Permit # \_\_\_\_\_ City of \_\_\_\_\_ BUILDING PERMIT APPLICATION Fee \_\_\_\_\_ Zone \_\_\_\_\_ Map # \_\_\_\_\_ Lot# \_\_\_\_\_

BUILDING PERMIT REPORT

ADDRESS: 187 Wayside Rd DATE: 10/feb/93  
REASON FOR PERMIT: To Construct deck (8x16')

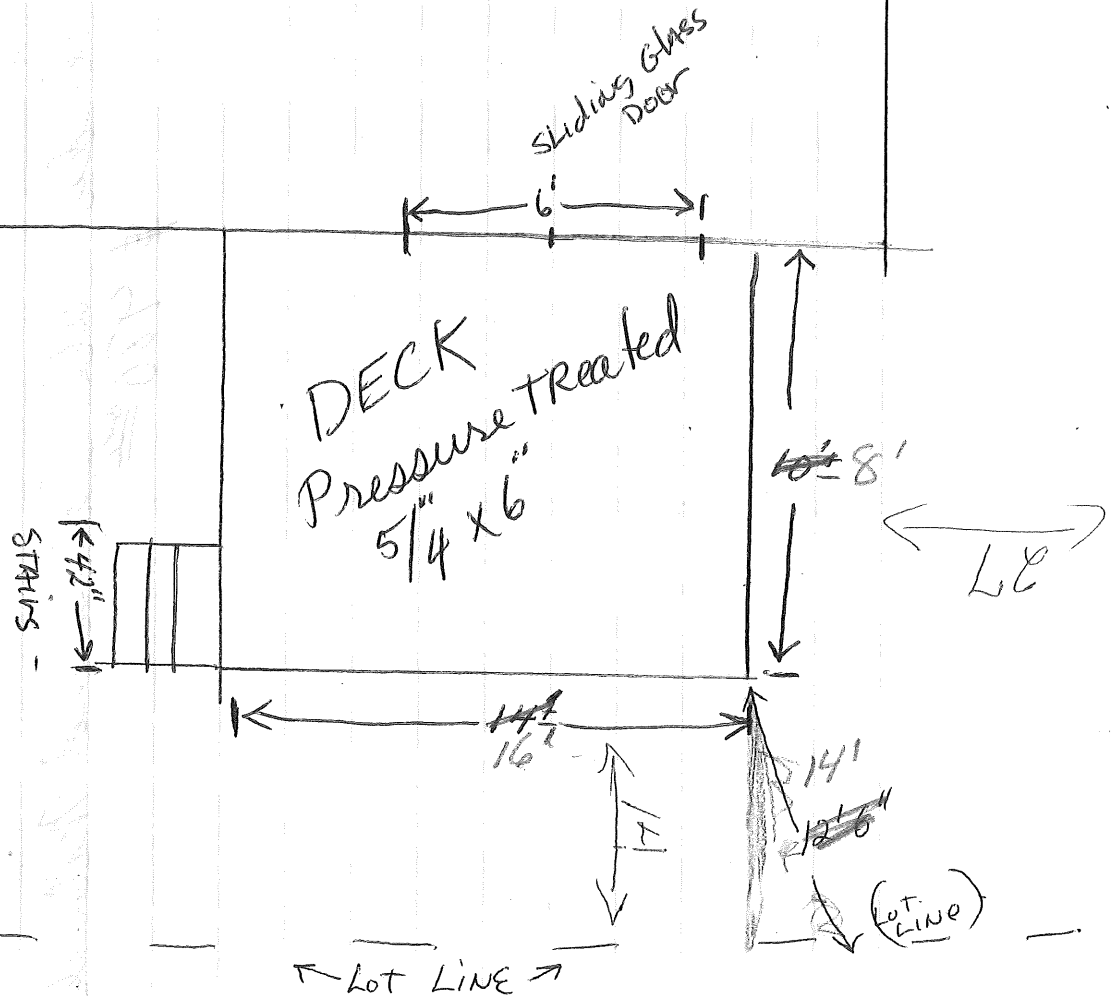
Construct 10'x14' pressure treated deck, to be built on 8" Sauna Tubes 4 feet in ground - Deck will be constructed of 2"x8" timbers supported by a 4"x6" Beam built on the sauna tubes. Decking will be 5/4" x 6" pressure treated lumber. Deck will include 1 set of stairs with railings - steps will be 42" wide. porch will be completely enclosed with railings 36" above deck and 2"x2" pressure treated balusters spaced 4" on center.

- ✓ Date - 4-6 - O.K.
- ✓ Zone Location - R3 - O.K.
- ✓ 40 ft. setback area? (Section 21) NO - O.K.
- ✓ Use - 2-Story dwelling - O.K.
- ✓ Sewage Disposal - Sewer - O.K.
- ✓ Intersect or Corner Lot - 20' needed - Have 22' - O.K.
- ✓ Rear Yards - 19' (14' minimum) - O.K.
- ✓ Side Yards - 25' - 30' O.K.
- ✓ Front Yards - 25' to overhang O.K.
- ✓ Projections - Overhang, bulkhead, chimney, porch - O.K.  
(6')
- ✓ Height - O.K.
- ✓ Building Area - 1,960' - House 672' O.K.
- ✓ Lot Area - 7,872' - O.K.
- ✓ Area per Family - O.K.
- ✓ Width of Lot - O.K.
- ✓ Lot Frontage - O.K.
- ✓ Off-street Parking - O.K.
